Access Compliance Report Public Rights-of-Way (Curb Ramps)

Main Street: ST_ALBANS_DR		Cross Street: WEATHERBY_RD		Location:	NW
ADA ID: RPRK211217133818	Ramp Type: Type 4 - Parallel	Initial Pass/Fail: Fail	Overall Compliance: No	Severity Score:	2
Codes/Mitigation Info/Possible Solution			Field Measurements/Component Compliance

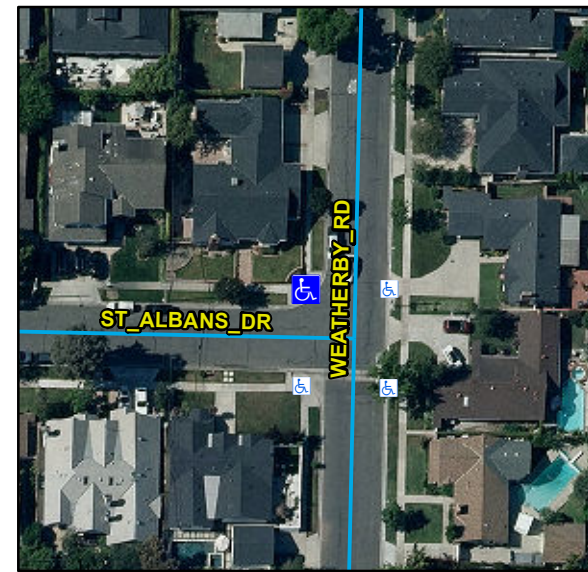
Compliance	Description	Data	Compliance	Description	Data
N/A	Ramp Length LT (in)	92	N/A	Ramp Length RT (in)	92
Yes	Ramp Width LT (in)	102	Yes	Ramp Width RT (in)	105
Yes	Ramp Run Slope LT (%)	7.4	Yes	Ramp Run Slope RT (%)	8.2
No	Ramp Cross Slope LT (%)	2.4	No	Ramp Cross Slope RT (%)	3.2
N/A	Landing Present	N/A	N/A	DWS Provided	N/A
N/A	Landing Length (in)	N/A	N/A	DWS Contrast	N/A
N/A	Landing Width (in)	N/A	N/A	DWS Length (in)	N/A
N/A	Landing Run Slope (%)	N/A	N/A	DWS Full Width	N/A
N/A	Landing Cross Slope (%)	N/A		DWS Offset Type	N/A
N/A	Landing Movement Obstructed?	N/A	N/A	DWS Offset Left (in)	N/A
	Landing Movement Type	N/A	N/A	DWS Offset Right (in)	N/A
N/A	Landing Shared	N/A			
N/A	Clear Space	Yes			
N/A	Clear Space To Crosswalk (in)	N/A			
N/A	Marked Crosswalk 1	No	N/A	Marked Crosswalk 2	No
	Crossing 1 Direction	S		Crossing 2 Direction	E
	Marked Crosswalk 1 Width (in)	N/A		Marked Crosswalk 2 Width (in)	N/A

Remove & Replace Curb Ramp With Two New Directional Ramps or Equivalent.

R304.5.3, STD 1115
